PREVOST

**WARRANTY
BULLETIN**

Wb99-39

DATE : NOVEMBER 1999	SECTION : 06 - Electrical
EXPIRATION: NOVEMBER 2000	
SUBJECT : TIGHTENING OF BATTERIE TERMINAL NUTS

FIGURE 1 : TYPICAL VIEW OF THE BATTERY CABLES

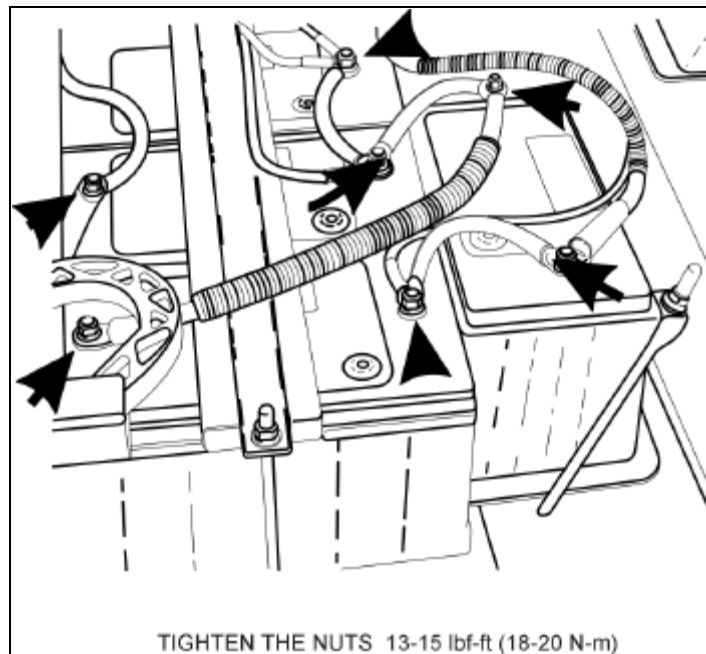
On the above mentioned vehicles, the battery cables may have been improperly tightened on the batteries. To make sure that the cables will stay in place, it is necessary to check the torque of the terminal nuts.

1. In the main power compartment, remove the battery plastic protective cover.
2. Using a torque wrench, tighten the terminal nuts to a torque of 13-15 lbf•ft (18-20 N•m).
3. Reinstall the battery plastic protective cover.

1. Locate the batteries in the rear baggage compartment.
2. Using a torque wrench, tighten the terminal nuts to a torque of 13-15 lbf•ft (18-20 N•m).

1. Locate the batteries in the engine R.H. side access compartment.
2. Remove the battery plastic protective guard.
3. Using a torque wrench, tighten the terminal nuts to a torque of 13-15 lbf•ft (18-20 N•m).
4. Reinstall the battery plastic protective guard.
